MANDATORY SERVICE BULLETIN

MSB 40-067

Check of emergency exit lever.

Check of emergency exit lever

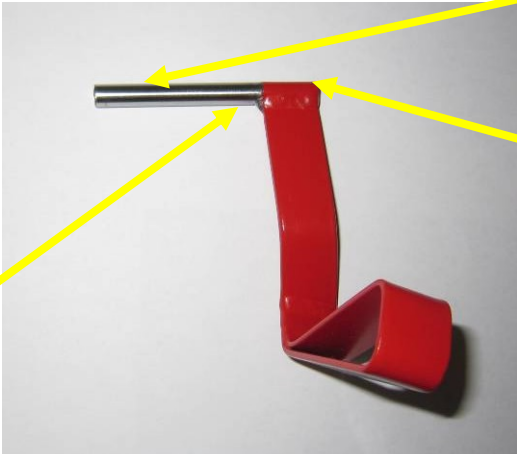
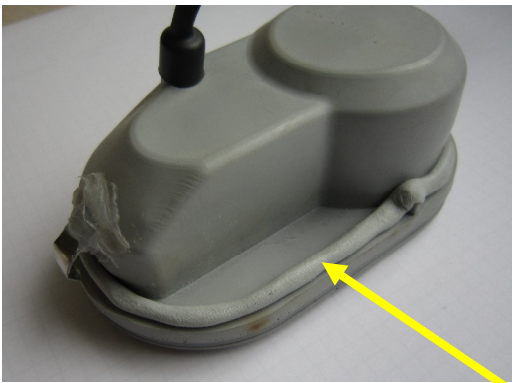
5	<p>Rework lever pin, refer to picture.</p> <div style="display: flex; justify-content: space-around; align-items: center;"> <div style="border: 1px solid black; padding: 5px; width: 150px;"> <p>Bend the pin if necessary maximum 3°</p> </div>  <div style="border: 1px solid black; padding: 5px; width: 150px;"> <p>Grind surface maximum 0,3mm (0,012 inch) and edge 3mm (0,12 inch) if necessary</p> </div> </div> <p style="text-align: center;">The minimum pin diameter is 5,7mm (0.225 in).</p>
6	<p>Install the modified emergency lever and test the release with hand force. If a release is possible, install the emergency exit lever.</p>
7	<p>If a release is not possible, replace the emergency exit lever with DA4-5200-71-00_1.</p>
8	<p>Seal reading light and emergency lever with Terostat IX.</p> <div style="display: flex; justify-content: space-around; align-items: center;">   </div> <div style="text-align: center; margin-top: 10px;"> <div style="border: 1px solid black; padding: 5px; display: inline-block;"> <p>Sealing Terostat IX</p> </div> </div> <p>CAUTION: Do not use silicone or any equivalent to seal the gap.</p>
